THE COMMONWEALTH OF MASSACHUSETTS
PHYSICAL PLANT BUILDING
FACILITIES PLANNING DIVISION
360 CAMPUS CENTER WAY
UNIVERSITY OF MASSACHUSETTS
AMHERST, MA 01003

ADDENDUM #1

Contract #: UMA11-37

Project Title: MORRILL II, HP ACCESS

ATTACHMENT 2

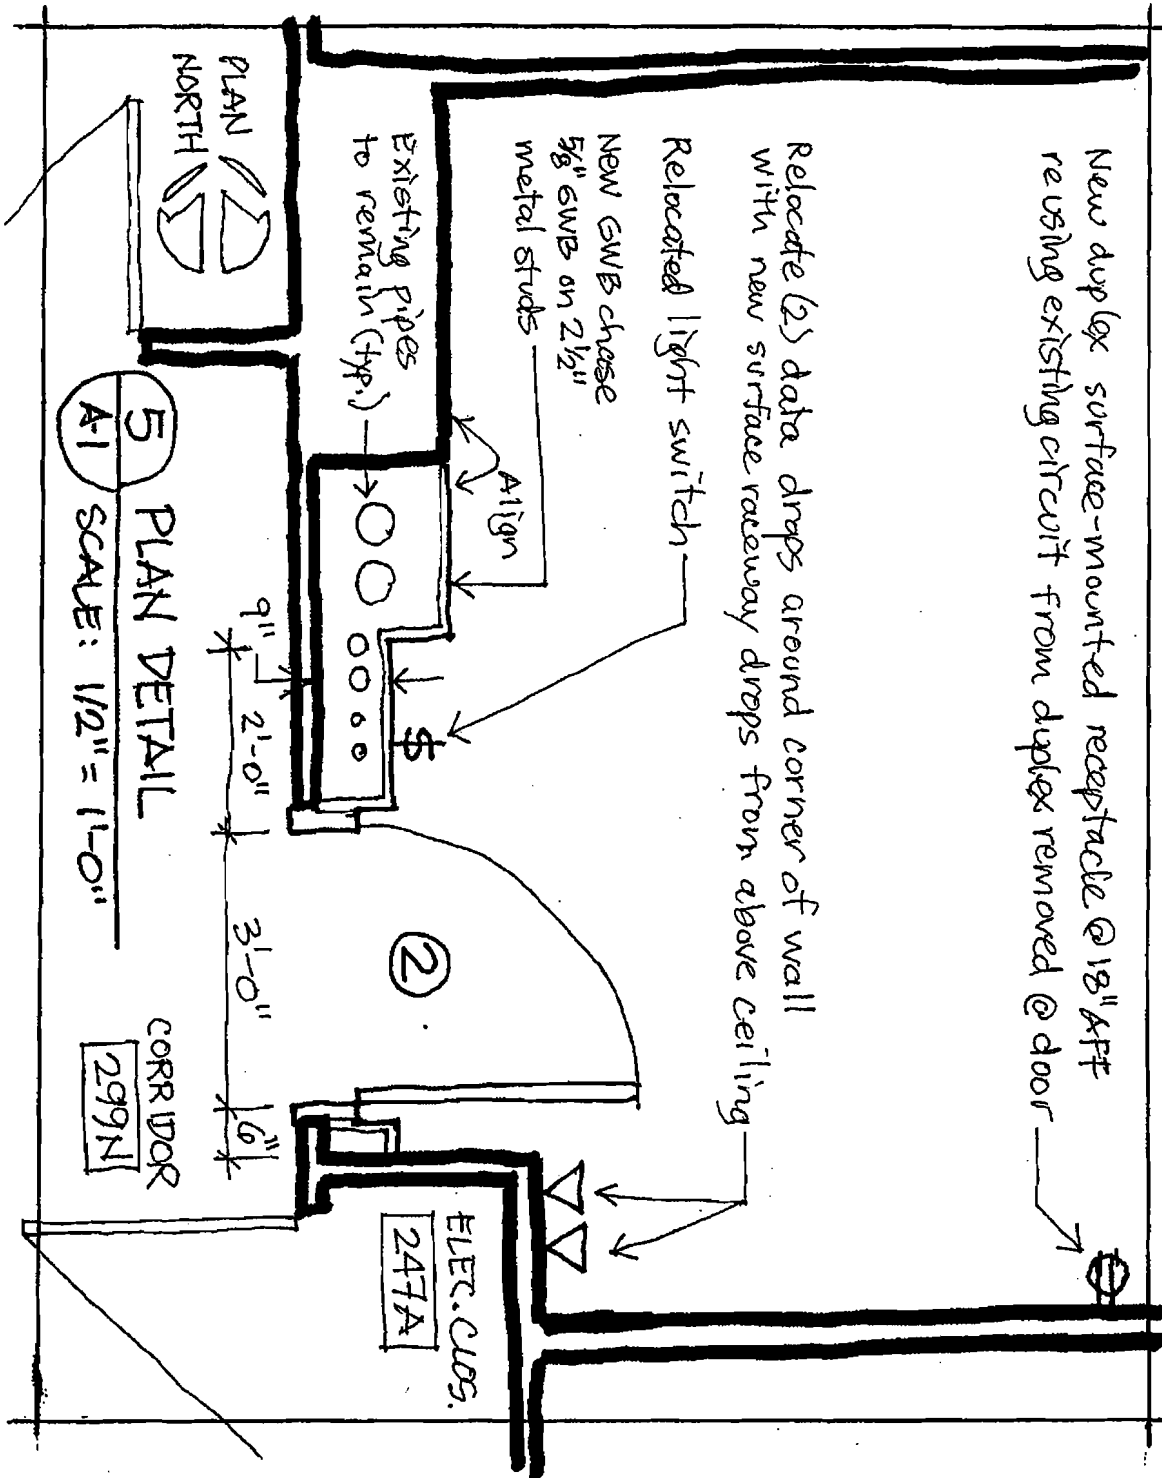
- Item 8. Drawing A-1, *ADD the new detail 5/A-1 (see Attachment 2) immediately to the right of existing detail 4.*
- Item 9. Drawing A-1, *ADD the new detail 6/A-1 (see Attachment 3) immediately to the right of new detail 5.*

8. Relocate the 2 existing data jacks from the short South wall (behind new door 2) to the short West wall as shown on detail 5/A-1 (see Attachment 2).

9. Locate new light switch in new gypsum chase wall as shown on detail 5/A-1 (see Attachment 2).
